PROJECT No.: SM 220069-E

September 30, 2024

**SUPPLEMENTAL ENVIRONMENTAL CONSIDERATIONS
RIVERFRONT – CHIPPAWA PARKWAY
NIAGARA FALLS, ONTARIO**

LOCATION PLAN (1:10000)

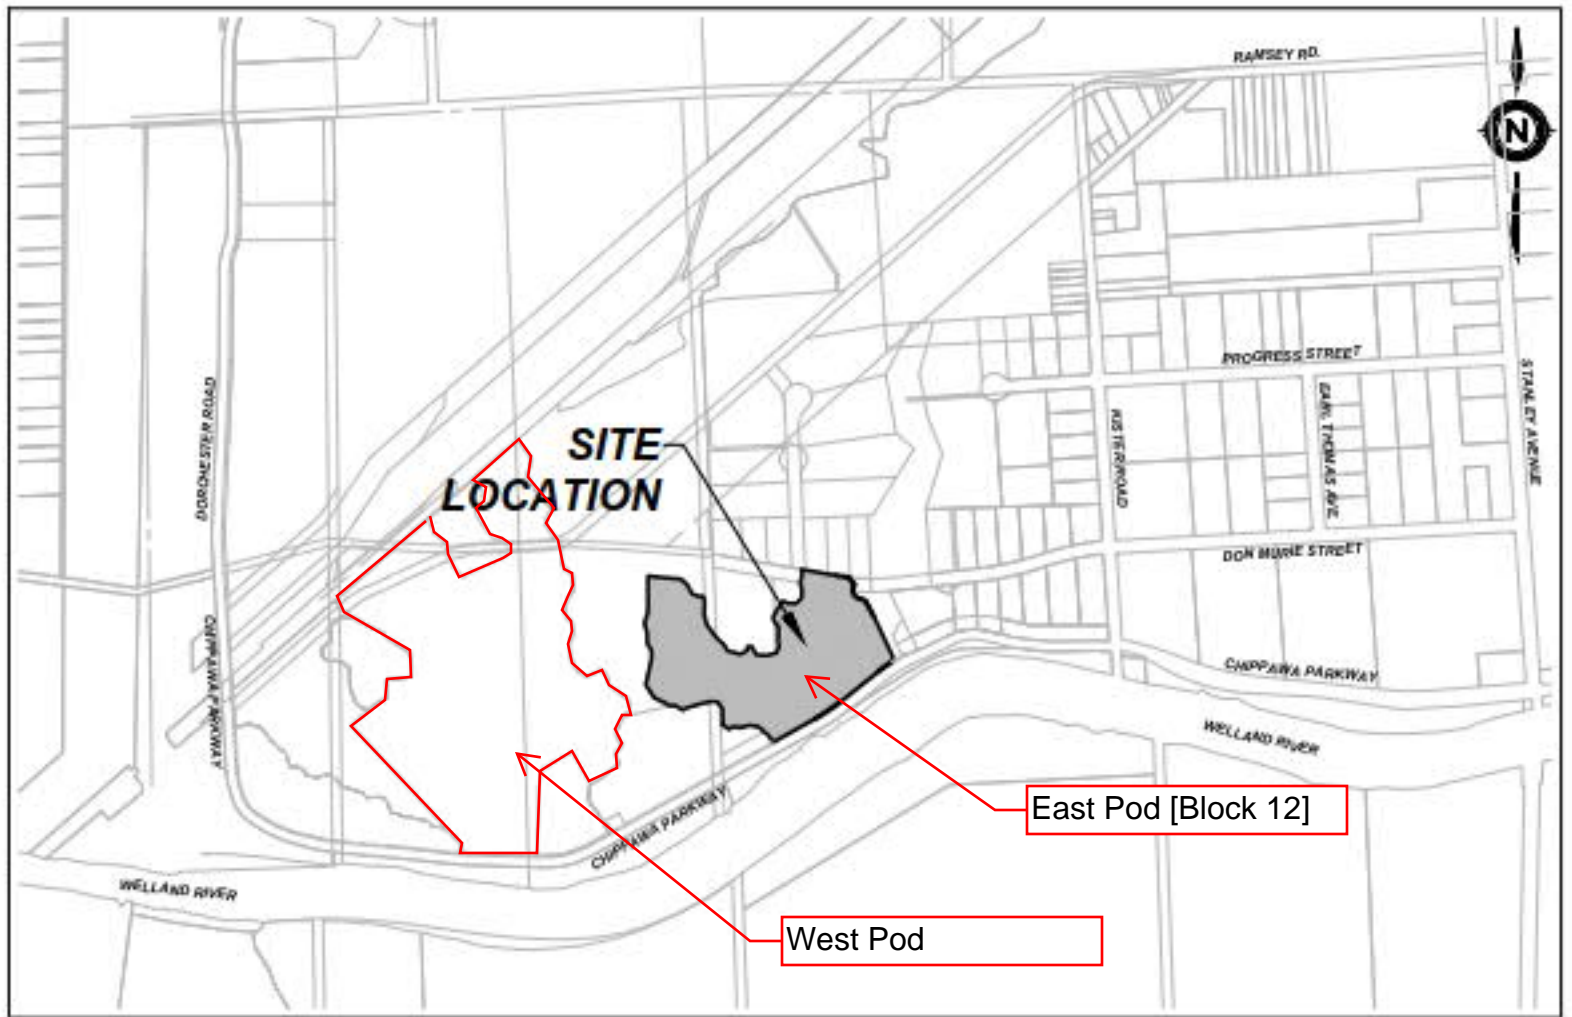
1) The locations (map) of east and west Pods

2) Clarification on area BH101 and how that exceedance is being addressed.

- The locations (maps) of the east and west development pods have been referenced from the previous Phase One and Phase Two ESA reports conducted by Wood Inc. The east pod refers to the eastern development lot [also referred to as Block 12] and the west pod refers to the western development lot as they were described at this stage of the project. The location plans have been appended to the end of this letter.

- Supplemental sampling was conducted in the area of BH103 and BH429, each located within the East Pod [Block 12], which is the present area of development. This confirmed the previously reported elevated levels of Thallium and Antimony were in fact isolated results, and not considered to be representative.
- It is anticipated that the same situation is the case at BH101, which is located in the northwest corner of the west pod, with the minor elevated Thallium value being isolated and non-representative. However, as this was not part of the development plans at the time further assessment was not yet conducted.

- As the filing of a Record of Site Condition is not required, given there is no change in land use to a more sensitive case, there is no specific requirement to remove the impacted soil. As such, there is not an immediate action required regarding the Thallium exceedance at BH 101. As the borehole is located north west of the proposed development plan at this time it is unlikely that any impacted soils, if in fact present, will be exported from site as excess soils. At such time when this would become necessary additional testing to confirm and delineate the exceedance would be conducted.

BH101 - isolated location of elevated Thallium, reported by others. Future assessment warranted if excess material to be removed from the site.

BH429 - isolated location of elevated Antimony, reported by others. Supplemental testing done prior to earthworks demonstrated as non-representative. No further concern.

BH103 - isolated location of elevated Thallium, reported by others. Supplemental testing done prior to earthworks demonstrated as non-representative. No further concern.
